Product / Process Change Notification (PCN)

PCN #: PCN_WL-SWTP_20230713

Affected Series: WL-SWTP; 1583012xx; 1583022xx; 1585634xx

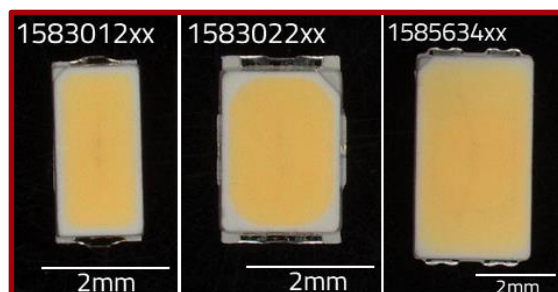
Due to external influences, Würth Elektronik is changing the raw material supplier for die and phosphor.
 All products with date code 2023-05-01 or later, will be affected by this change.
 There will be no change in fit, function, quality or reliability of the product.

VISUAL APPREARANCE:

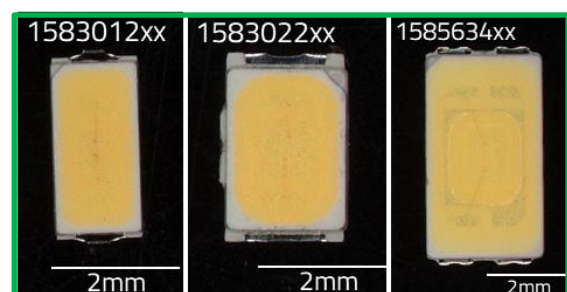
Due to availability of die and phosphor converter materials, the die and phosphor have been changed. The markings, fit, function, quality, reliability and datasheet of the product do not change.
